File 1990-0043

Name 1<sup>st</sup> Presbyterian Church – Revised Final Plan NE Corner of 27.5 & Cortland Avenue

REVIEW SHEET SUMMARY

FILE NO. #43-90 TITLE HEADING: Revised Final Plan  
ACTIVITY: Revised Final Plan / First Presbyterian Church  
PETITIONER: First Presbyterian Church  
REPRESENTATIVE: Self RESPONSE NECESSARY  
by NOV 2 1990  
LOCATION: Northeast corner Cortland Avenue & 27 1/2 Road  
PHASE: Final ACRES: 8.97 acres  
PETITIONER'S ADDRESS: 622 White Ave, Grand Junction  
ENGINEER: Reck & Associates, 9605 W 49th St, Wheatridge, CO 80033  
STAFF REPRESENTATIVE: David Thornton

**SITE PLAN**  
1" = 30'-0"  
NORTH

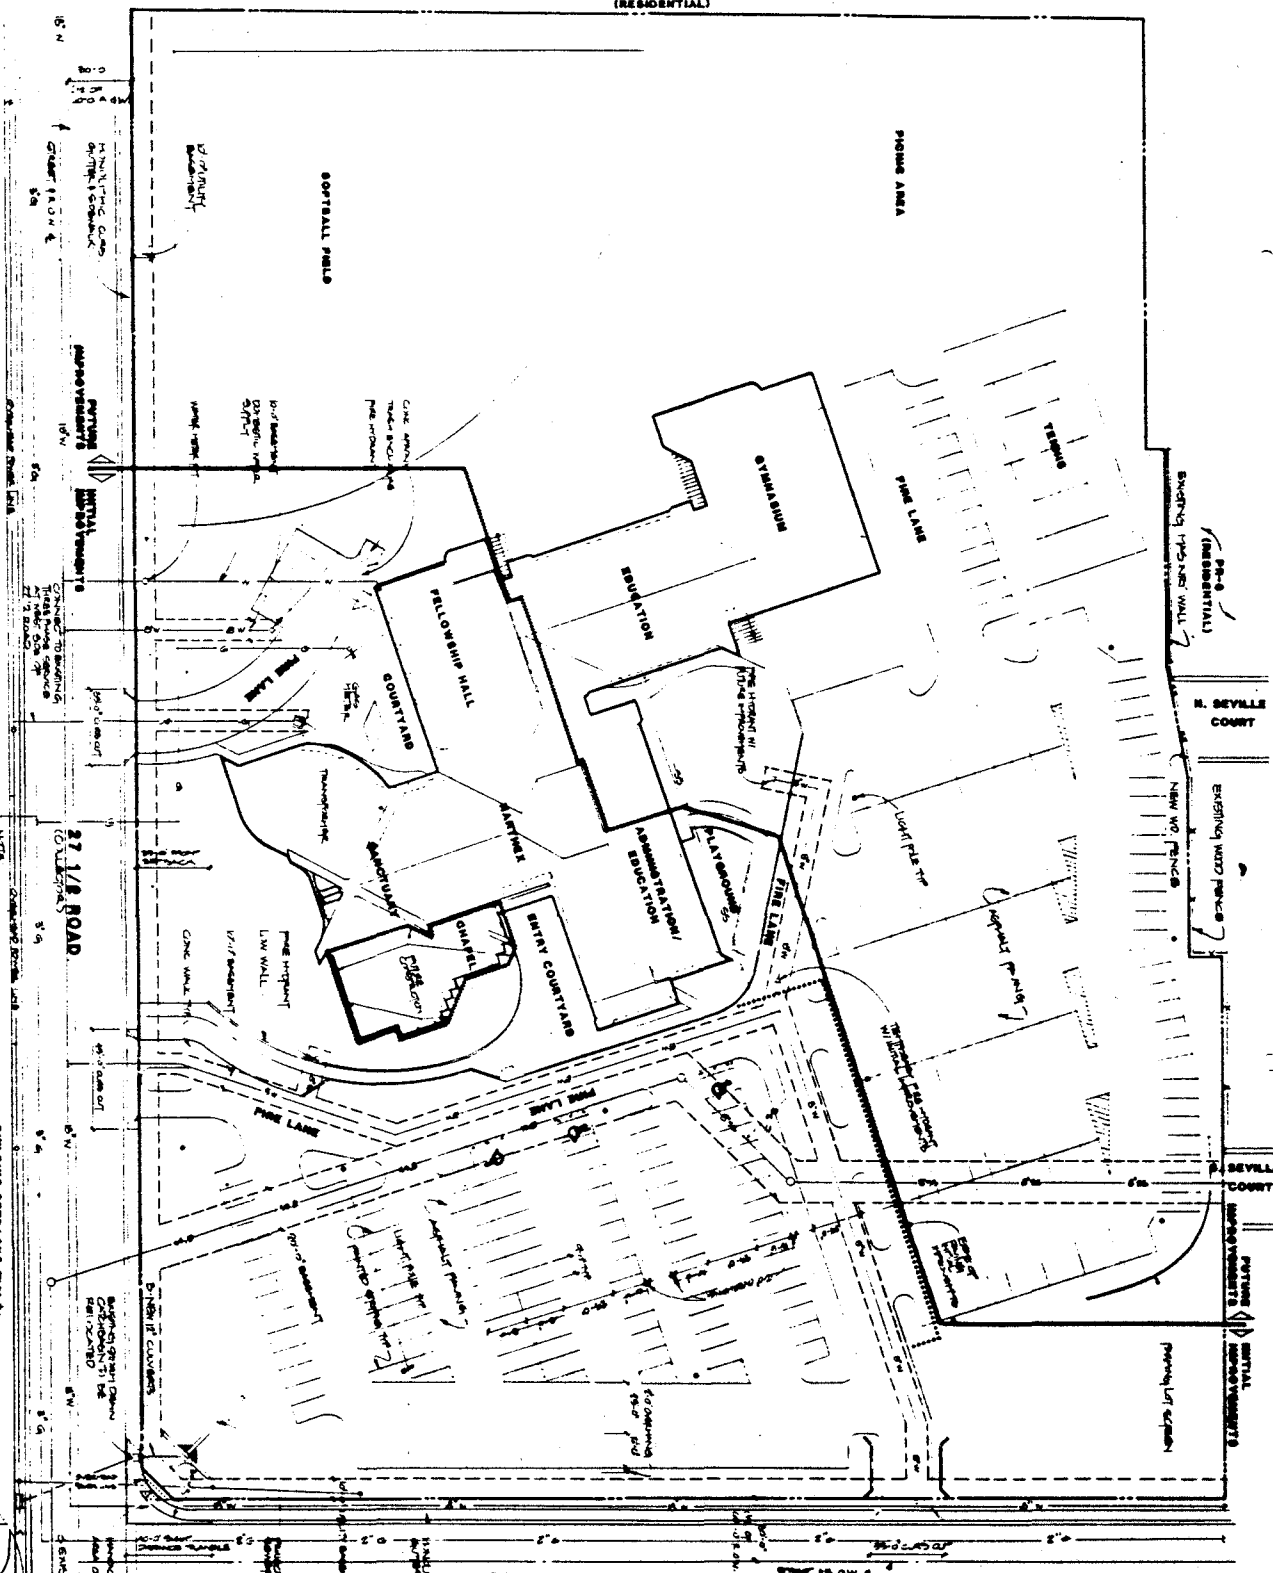
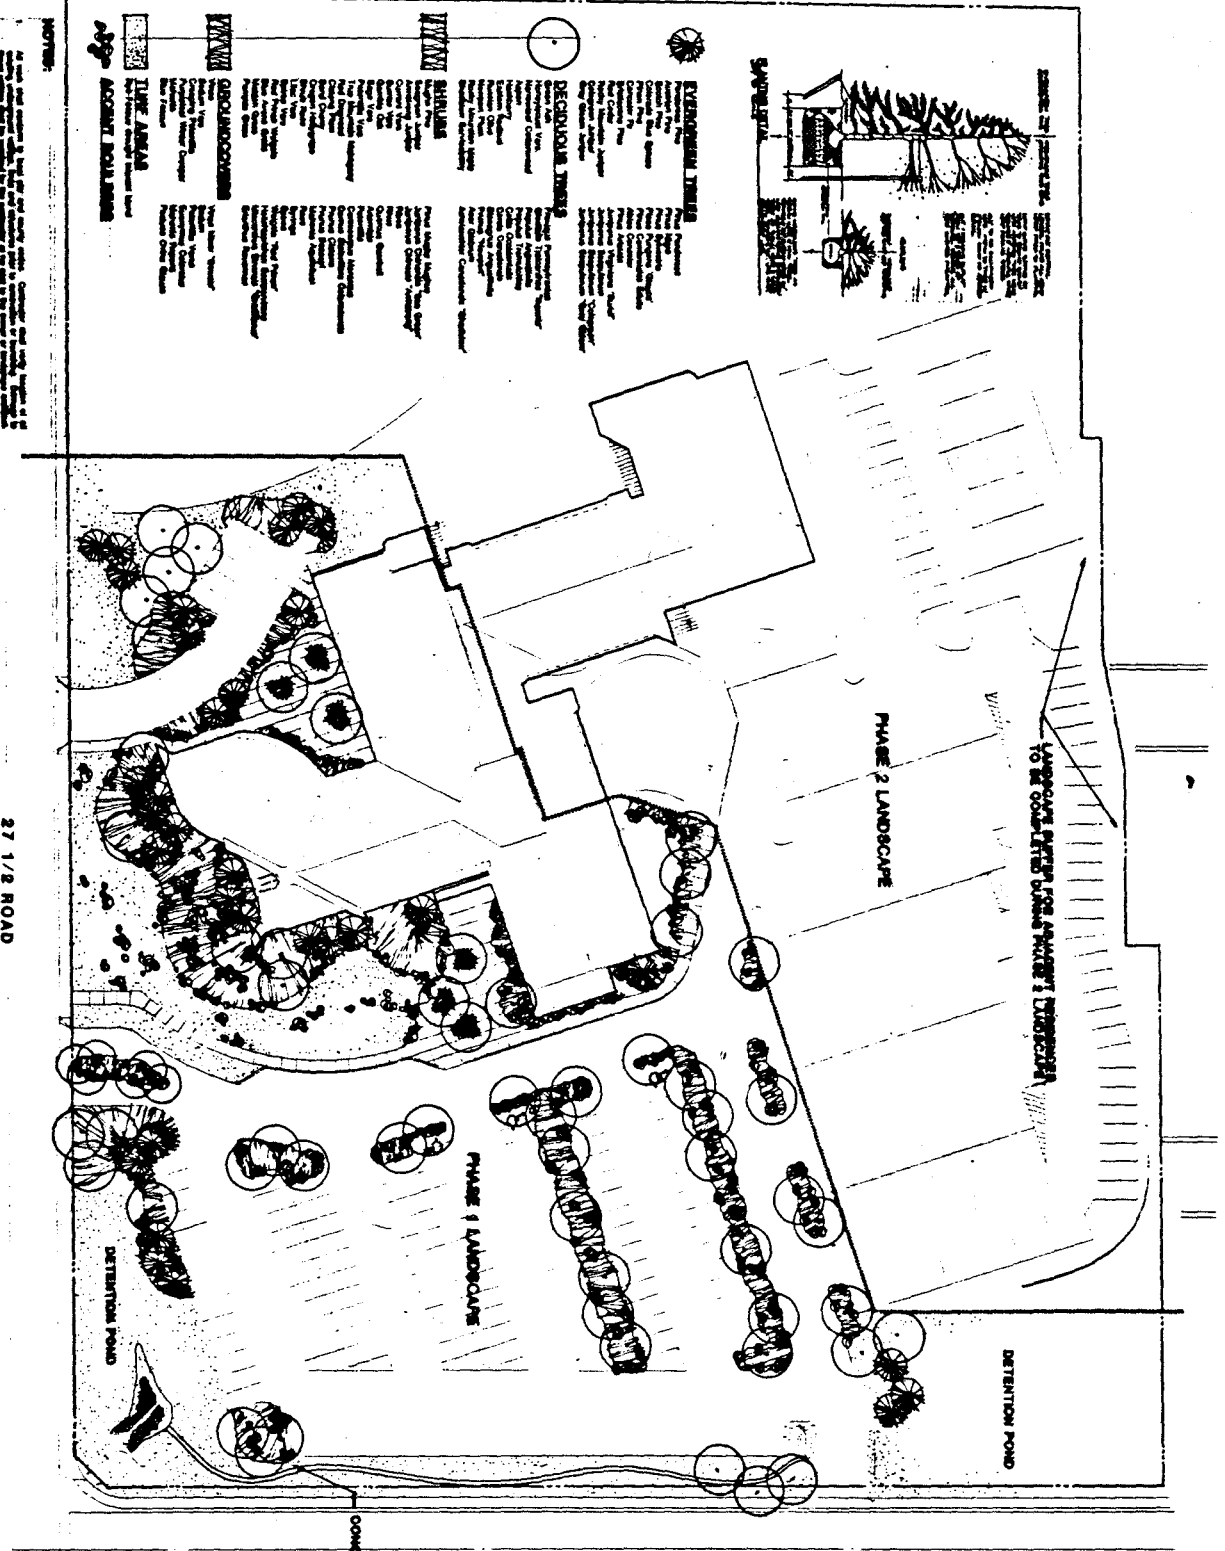
2. We need to know size of plantings for Phase I Landscaping. The minimum allowable plant size for new installations shall be 1 1/2 inch caliper for deciduous, six feet tall for evergreens, and five-gallon size for shrubs.

5. Landscaping plan for Phase II will need to be approved by our office prior to Phase II construction.
6. All parking area/security illumination shall be arranged so as to confine direct light beams to the lighted property and away from nearby residential properties and the vision of passing motorists.

- Lighting shall be provided at areas indicated on the Site Plan (Sht. 1) to provide night lighting for security, safety, adequate visibility for maneuvering and to emphasize entrances, exits and hazards. Lighting shall be designed so as not to unreasonably disturb occupants of adjacent residential properties.
- Fences and walls shall be placed as indicated on the Site Plan and future plantings established so as to screen adjacent residential properties to prevent disturbance due to the maneuvering of vehicles entering and leaving the parking area.

Lighting shall be provided at areas indicated on the Site Plan (Sht. 1) to provide night lighting for security, safety, adequate visibility for maneuvering and to emphasize entrances, exits and hazards. Lighting shall be designed so as to confine direct light beams to the lighted property and away from nearby residential properties and the vision of passing motorists.

**FIRST PRESBYTERIAN CHURCH**  
**DRAINAGE / GRADING PLAN**

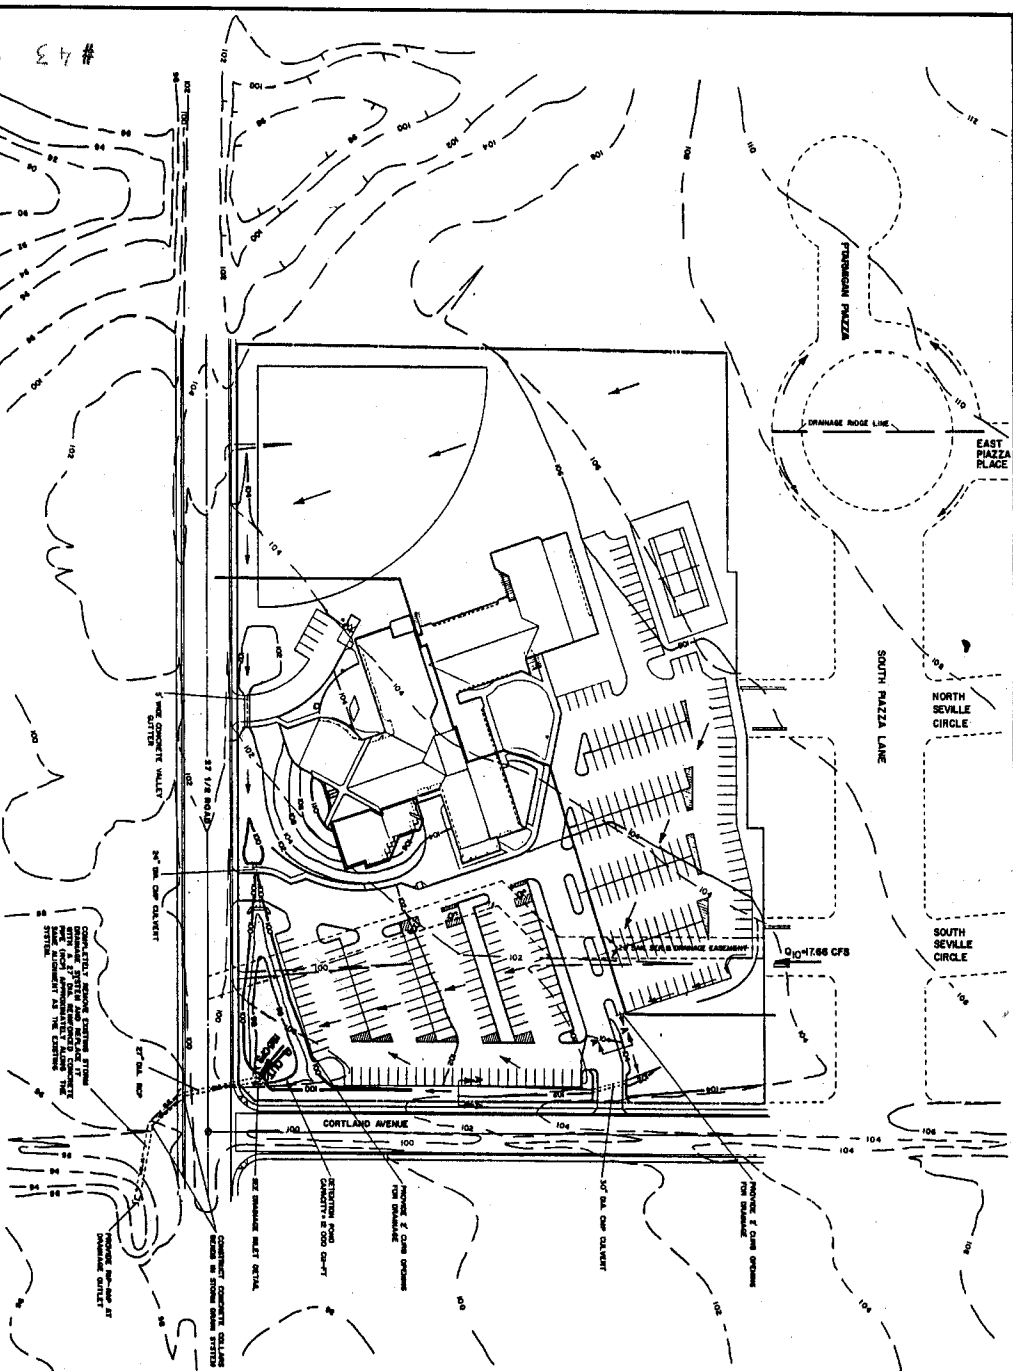
Storm runoff volume from the site is over estimated using peak Q for entire duration of the storm. How does this affect the size of outlet from the detention basin? How was Q from Apple Crest Subdivision determined? Show calculations. Drainage inlet from detention basin should allow direct access to the top of the outlet pipe for maintenance purposes. What are "concrete collars" shown at bends in storm drain pipe crossing 27 1/2 Road? Storm runoff from Apple Crest appears to be directed across the parking lot surface. Recommend that a concrete drainage pan or pipe be installed to prevent deterioration of the parking lot.

The discharging of up to 19.5 CFS of water into the channel located off this property, as per drainage plan, will undoubtedly cause downstream problems along the channel clear to or beyond 27 Road. While the channel at its upper end where the proposed discharge would enter is of sufficient size to carry the flow, the same cannot be said for it some 1/4 +/- mile downstream and particularly at crossings along the channel.

As a result of our discussions it was concluded that; 1) the release rate  
from the site would be equivalent to the historic release rate of approximately  
9 cfs, 2) there would be a 5 foot drainage easement dedicated adjacent to  
the 10 foot utility easement along the southerly property line of the site,  
and 3) the location of the drainage inlet for the lower detention pond would  
be located in such a way to provide easy access to the top of the outlet pipe  
for maintenance purposes.

Upon review of your comments concerning the amount of proposed discharge of up to 19.5 cubic feet per second (cfs) into the channel located off the church property, and realizing the potential impact of this discharge downstream, we have revised the initial Drainage Plan for the First Presbyterian Church to address your concerns.
